III. Single/Multiple Element Tripping with Protection Violation

S. No.	Event	Event Analysis	Outage Date & time	Points for Review	Remedial Actions Furnished
1	400KV-TIPPAPUR-CHANDALAPUR-2	As per the reports submitted 400 kV Tippapur-Chandalapur line got tripped due to suspected earth leakage in Chandalapur end. The line got tripped at Chandalapur end. DT was sent from Chandalapur end and DT was received at Tippapur end and it tripped. As per the reports submitted 400 kV Chandalapur-Gajwel line tripped at Chandalapur end only due to earth leakage fault. No DR triggered at Gajwel end and line still in the service at Gajwel end.	16-03-2026 12:28	TGTRANSCO: 1. Tripping of the line due to DC earth leakage needs review

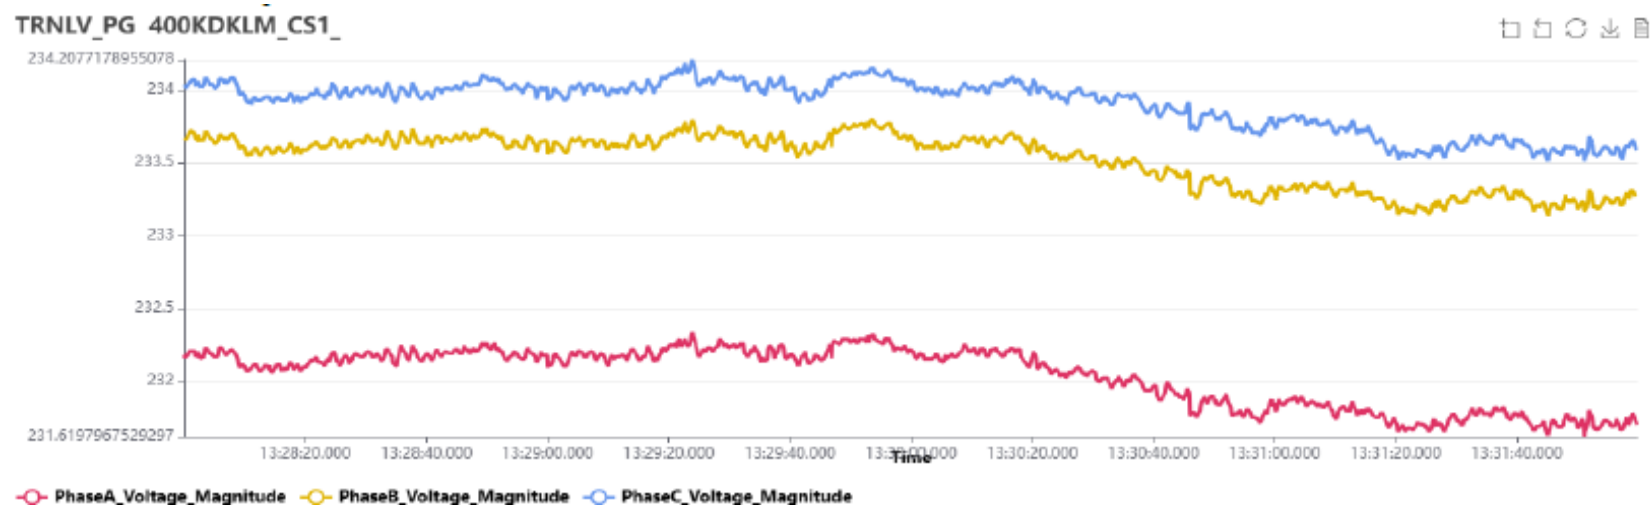
S. No.	Event	Event Analysis	Outage Date & time	Points for Review	Remedial Actions Furnished
19	400KV-KAYATHAR-KANARPATTI-1	As per the reports submitted, tripping in the line initiated by human error during testing process of ICT in 400 kV Kayathar bay. Due to this testing error LBB protection at Kayathar end started and DT signal send to Kanarpatti end. After receiving the DT signal line got tripped at Kanarpatti end.	20-04-2026 13:30	<u>TANTRANSCO:</u> 1. The maloperation of LBB needs review.

➤ From the PMU plot no fault was observed.

1. As per the reports submitted, tripping of the line was initiated by human error during testing process of ICT in 400 kV Kayathar bay. Due to the testing error, LBB protection at Kayathar end started and DT signal was sent to Kanarpatti end. Kanarpatti end also tripped, after receiving the DT signal.
2. TANTRANSCO informed that during testing of New Bay, the LBB trip links were not isolated. During secondary injection in R phase of new bay, it was found that 86 operated & LBB initiation persisted with this condition, but while carrying out secondary injection in Y phase LBB operated. Hence main CB connected in Bus-1 got tripped and all elements were in service through Tie breaker.
3. During the LBB operation DT was sent to Kanarpatti end and TANTRANSCO informed that same would be rectified during upcoming LC.
